HIGHER GROUND DESIGNS, INC. Landscape Architecture, Planning & Irrigation design 5350 North Academy BLVD. Ste. 207 5350 North Academy BLVD. St						
		HIGHER GROUND					
	ILLS REC CENTER ICH ROAD COLORADO	THESE DRAWINGS ARE THE PROPERTY OF HIGHER GROUND DESIGNS, INC. AND SHALL NOT BE USED FOR ANY OTHER PURPOSE WITHOUT WRITTEN AUTHORIZATION BY HIGHER GROUND DESIGNS, INC. THESE DRAWINGS ARE NOT FOR CONSTRUCTION.					
	WOODMEN HILLS R 9205 MERIDIAN RANCH ROAD EL PASO COUNTY, COLORADO	PREPARED FOR: HAMMERS CONSTRUCTION					
NOT FOR CONSTRUCTION	JOB NUMBER 953-2 REVISIONS 12-17-20 PER COMMER DESCRIPTION LANDSCAPE PLAN SHEET NO. L1.1	NTS

### Landscape Plan\_V2.pdf Markup Summary

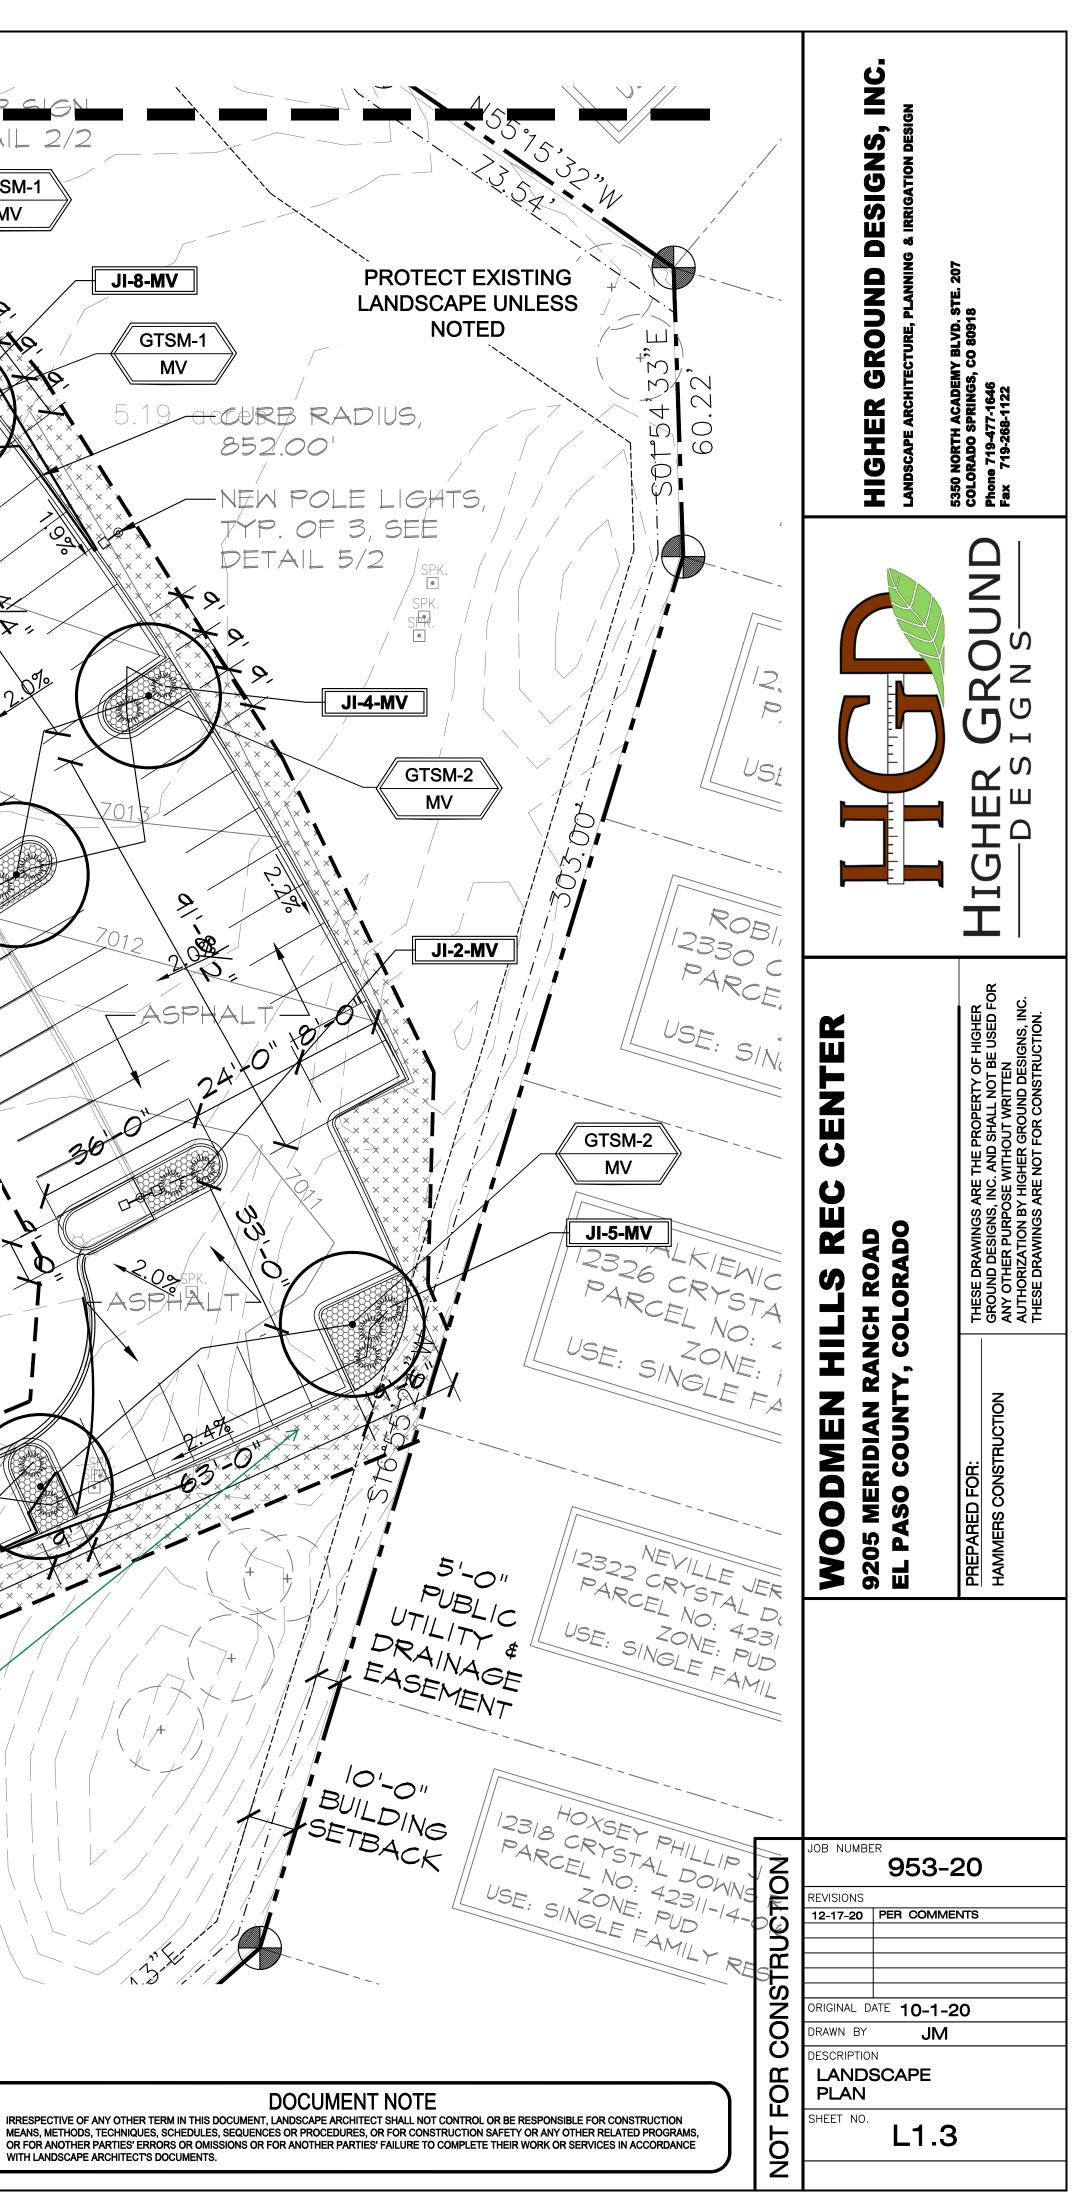
RA PFS-3-MV GTSM-1 MV SITE ∫BENCHMARK ELEV: 1Ø17.15' JI-2-MV SIDEWA NA / JI-7-MV **PROTECT EXISTING** LANDSCAPE UNLESS NOTED  $\mathbf{X}$ X 5  $\mathcal{N}$ PROTECT EXISTING LANDSCAPE UNLESS NOTED EDGE OF [Repeat comment, comment unresolved]: 10' LAN Landscape buffer looks to not meet the SETBA landscape requirement for buffering/screening 54-0 of parking spaces adjacent to the residential use by at least a 3' shrub height. Please refer to Landscaping requirements in Chapter 6 of the Land Development Code. If it is the intent to provide screening primarily via the privacy fence, then please make that specific request to waive landcasping's parking lot screening requirements per Ch. 6 within the Letter of Intent, justifying the reason that the fence suffices, for Planning Director approval. **UTILITIES NOTE** VERIFY LOCATION AND DEPTH OF ALL UNDERGROUND UTILITIES PRIOR TO START OF WORK. CALL 811 FOR UTILITY LOCATES. ANY CONFLICT BETWEEN

[Repeat comment, comment unresolved]: Landscape buffer looks to not meet the landscape requirement for buffering/screening of parking spaces adjacent to the residential use by at least a 3' shrub height. Please refer to Landscaping requirements in Chapter 6 of the Land Development Code.

If it is the intent to provide screening primarily via the privacy fence, then please make that specific request to waive landcasping's parking lot screening requirements per Ch. 6 within the Letter of Intent, justifying the reason that the fence suffices, for Planning Director approval.
